Response to the request for review for the CDM project activity

Response to the request for review for the CDM project activity **"Use of biomass as an alternative fuel for the production of Calcium Oxide"** **(Ref. no.: 10016)**

2015-12-12

Graph 01. Historic price of pet coke (decreasing by 2009)¹

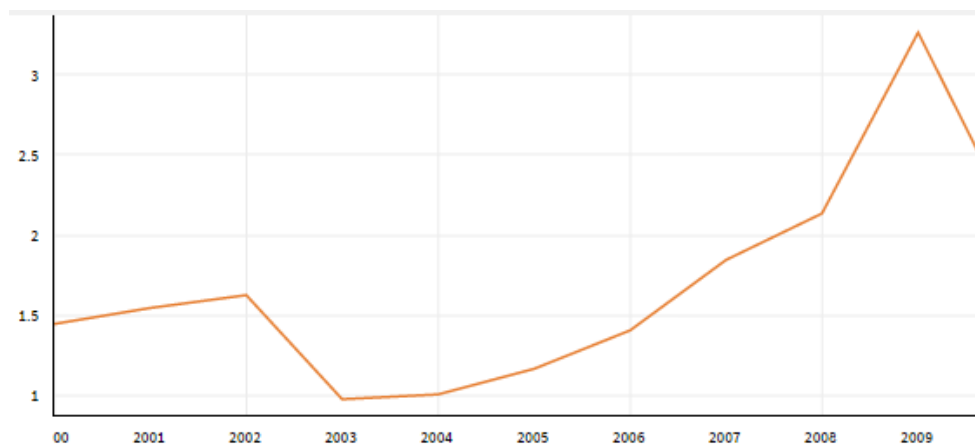
(ii) the investment analysis has been conducted based on the marginal effect of the project activity (for example, revenue comes from the savings of fuel costs due to the fuel switch from baseline scenario to project scenario). In doing so, a breakdown of the investment costs shall also be provided, in which each component of the investment costs can be illustrated, in particular the investment costs due to the installation of the new 600 tpd kiln.

As can be seen, the IRR benchmark (12.2%) is exceeded when the price of biomass decreases 10% (which is not likely to happen because this price is the most regular, is supported by a third party supplier whose quotation and description of the price is explained below on c). On the other hand, the benchmark is also exceeded when the price of pet coke increases 10% since its value on 2009 was decreasing according to Quandl on Graph 01.

A breakdown analysis was provided joint with this response; information (and references) have been included in the latest version of the FVR.

Graph 02. Biomass price (USD) of the Project 10016 “Calcium Oxide” compared to CDM’s already registered in Mexico

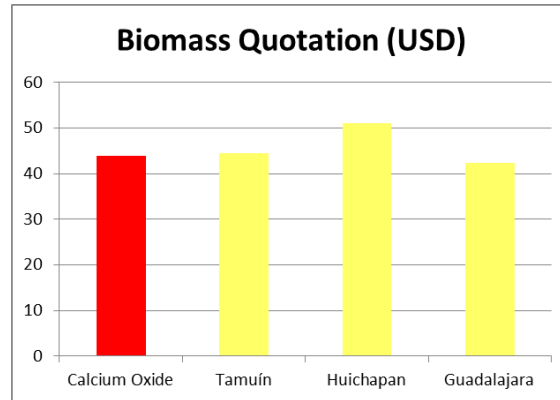
(c) Moreover, the investment analysis considers a price for the Agroindustrial Residues of USD 43.84 /ton, which is 40% of the price considered for Petcoke. The PDD states on its page 5 that these residues are otherwise sent to the landfill. Therefore, it has to be further substantiated how realistic is that these residues reach such a high market price (the IRR value when considering a price of zero is 30%). According to the validation report, the reference provided for justifying this price was cited as "quotation of forestry residues". The DOE is therefore requested to further justified how the price of agroindustrial residues has been validated, considering that the mentioned validation source refers to the price for forestry products and not to agroindustrial residues. Furthermore, the DOE is requested to validate this input value according to paragraph 129(b) of VVS version 9, which requires the use of third party or public available sources.

As can be concluded from Table 04, the price of the agroindustrial residues considered for the project are pretty similar compared to other biomass substitution projects in Mexico already registered as CDM's. In the following years, the registered projects have a similar variation of the price of biomass regarding to the price of petcoke (about 40%). These results can be better appreciated in the following graphs:

Therefore, it is concluded that the price of the biomass has been validated by third party and public available sources. It has been demonstrated that the price of 43.84 USD is realistic in the market according to the cost of the management process required to use it as a fuel and it is within the price range of similar projects in Mexico previously registered as CDM’s.
